Public Comment No. 1652-NFPA 70-2024 [Global Input]

This Global Public Comment is for CMP-12 to review the use of the terms "overcurrent", "overcurrent protective devices" and "overcurrent protection".

~~Figure Informational Note 620.62 Selective Coordination for Overcurrent Protective Devices Supplying More Than One Elevator.~~

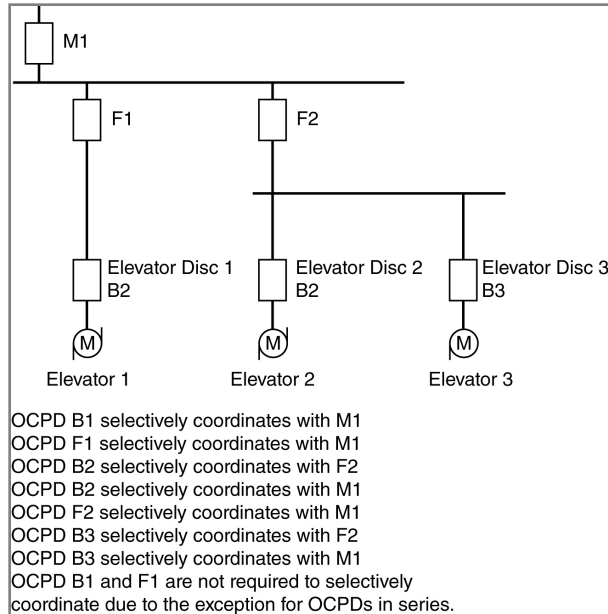
Please note that it is NOT my intent to delete this drawing, but rather to point out the problem with it. The drawing indicates that OCPD B1 coordinates with M1. The problem is...there is no B1 in the drawing. The disconnect on the left is probably supposed to be B1, but instead two of the three disconnects are marked as B2. I know of no way in Terraviva that I can fix this, other than to just point it out to the CMP.
